ALTERATION TO A HISTORIC PROPERTY STAFF REPORT

Site: 46 Mount Vernon Street c.1885 George Poole House
Case: HPC 2013.089 Single Building Local Historic District

Date of Application: November 18, 2013
Legal Notice: Add 3rd floor egress, alter roofing material
Staff Recommendation: Conditional Certificate of Appropriateness
Date of Public Hearing: January 21, 2014

46 Mount Vernon Street
showing sight-lines

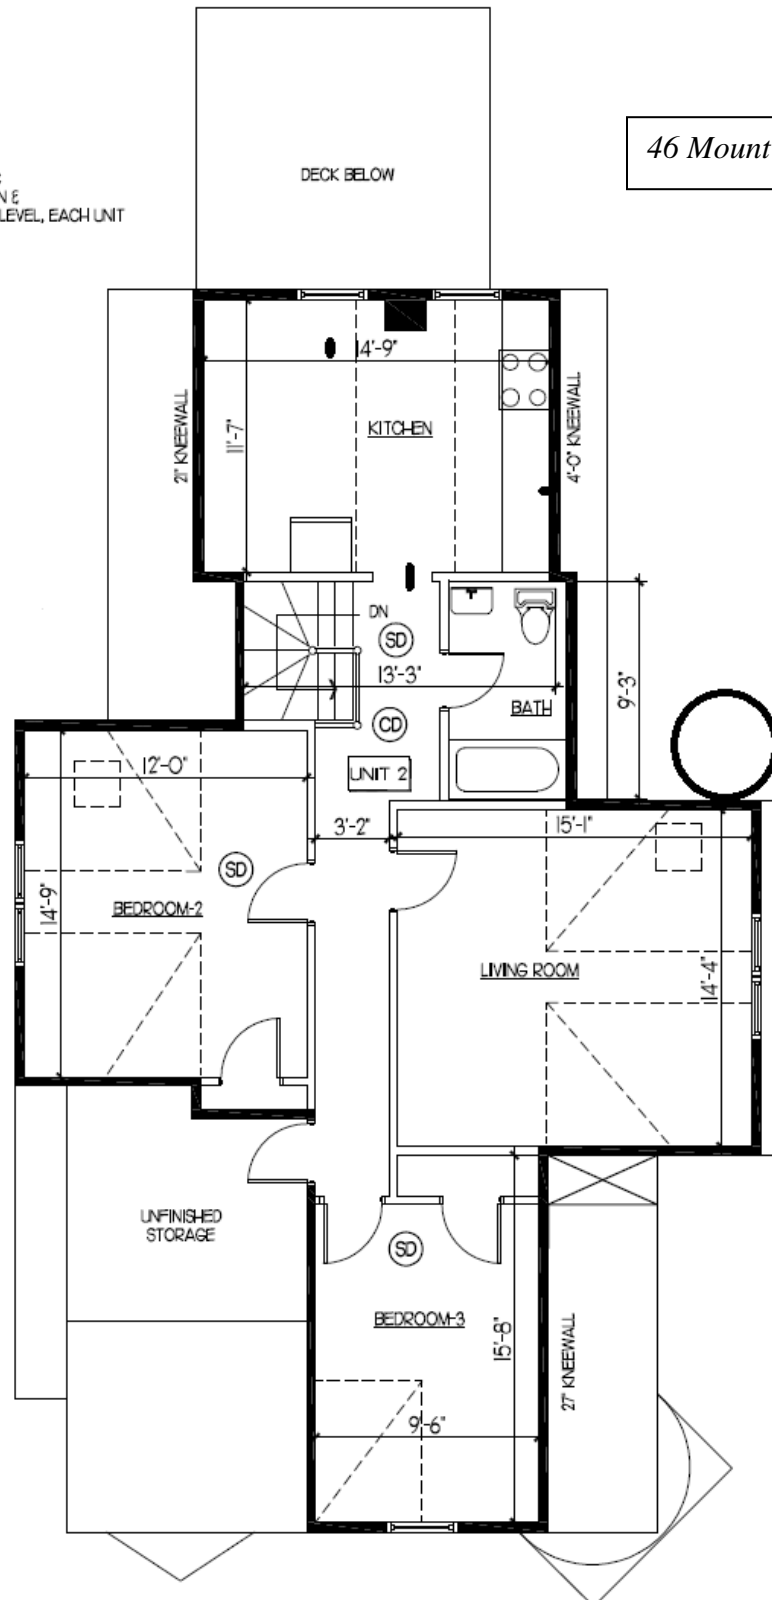
The enlarged window and egress platform will not be visible from the public right of way. The spiral stairway will protrude behind the cross gable edge of the building about 1' and will be partially more visible when the house is viewed from in front of 48 Mount Vernon Street.

The stairs will be partially visible on the southeast side behind the cross gable of the building near the driveway.

The fire escape/ second means of egress for the third floor apartment will be placed as inconspicuously as possible behind the cross gable and have as small a footprint as possible. It will protrude approximately 1' from the side when viewed from the front and will become more visible as one moves down to 48 Mount Vernon Street.

Staff determines that the alteration for which an application for a Historic Certificate has been filed is in part appropriate for and compatible with the preservation and protection of the 46 Mount Vernon Street Local Historic District; therefore **Staff recommends that the Historic Preservation Commission grant Ting Fang, Owner a Certificate of Appropriateness** for the installation of a simple metal spiral fire escape behind the cross gable and situated as close to the inside corner as possible. **Staff does not recommend that the Historic Preservation Commission grant a Certificate of Appropriateness** for the replacement of 3-tab asphalt shingles with Timberline architectural shingles. **Staff does recommend granting a Certificate of Appropriateness** for an architectural shingle with regular right angle cuts and a larger scale. **A Certificate of Non-Applicability** has already been issued for replacement in-kind of 3-tab asphalt shingles.

46 Mount Vernon Street conceptual sketch

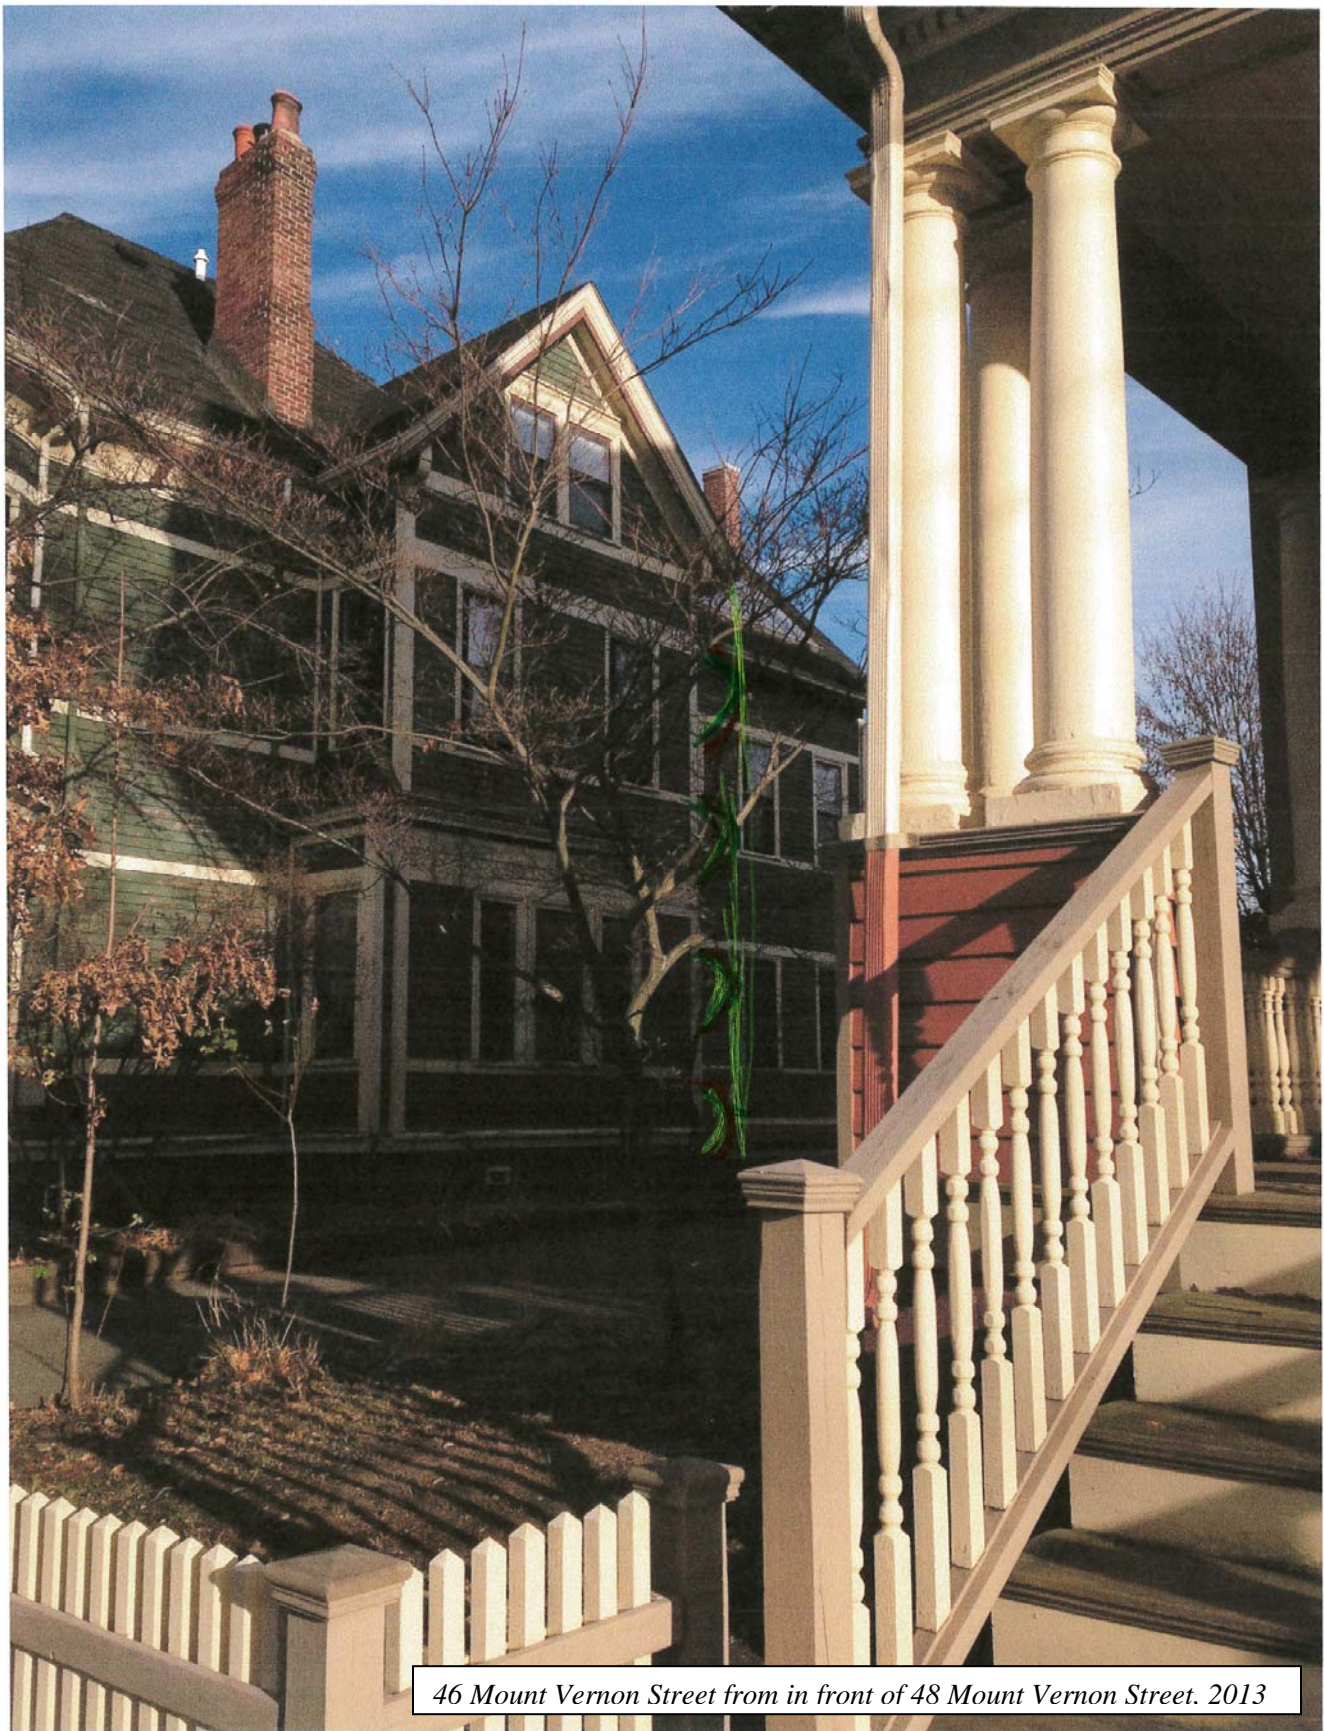
The owner proposes to enlarge the dormer window on the rear driveway side of the building to allow for access to a new spiral staircase to the ground level deck. This would be inserted into a corner of the building and would protrude 1' toward the driveway.

The spiral staircase will be simple metal and not match any of the existing features.
